SAFETY RECALL NOTICE

Subject <u>Aftermarket Steering damper SD033/038 BMW S1000RR & SD037 BMW R1200 R</u>	Report number 130627-SD	Date 2013-07-02	Page 1(3)
Author Peter Andersson	Distribution Distributors

Aftermarket Steering damper SD033/038 BMW S1000RR & SD037 BMW R1200 R

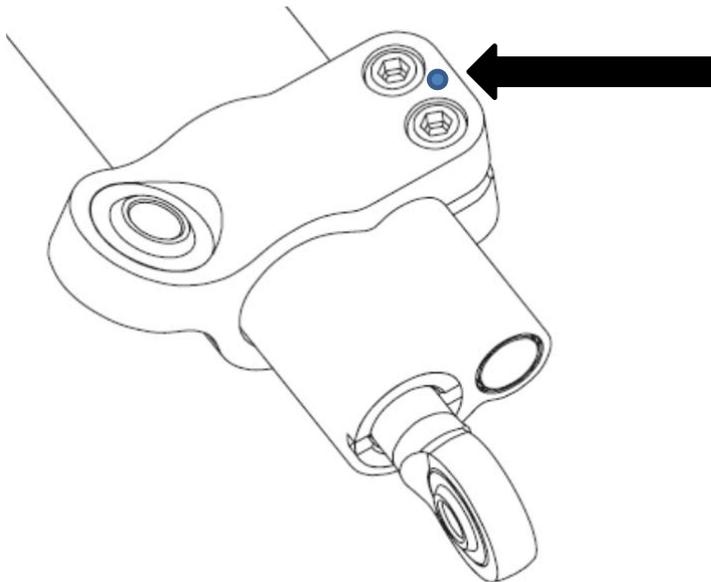
We regret to inform you that we have discovered a safety issue with the risk of cracks occurring in the bracket for the Aftermarket steering dampers SD033/038 for the BMW S1000 RR and SD037 for BMW R1200 R.

The cause is material being machined in an unfavorable direction in combination with probable material defect and the aluminum alloy being sensitive for stress corrosion cracking.

After July 10th 2012 this material has been replaced and the issue does not exist on steering dampers produced after this date. Seven known cases have been discovered so far and as a result of this we have decided to recall all sold steering dampers of these batches. There is a risk if the bracket will fail, that the steering angle will be less in one direction. Riders can notice that when they take off for a ride, or push the bike in a garage or parking spot and use the steering in a small radius. There is no risk for riders losing the control during normal riding, only if steering angle will be at max in one direction.

The batch numbers for the steering dampers with this safety issue is listed on page 3. New brackets will be manufactured and sent out to you for replacement with a preliminary starting date in September. The replacement bracket will be easy to identify with a small dot between the two small clamp screws´.
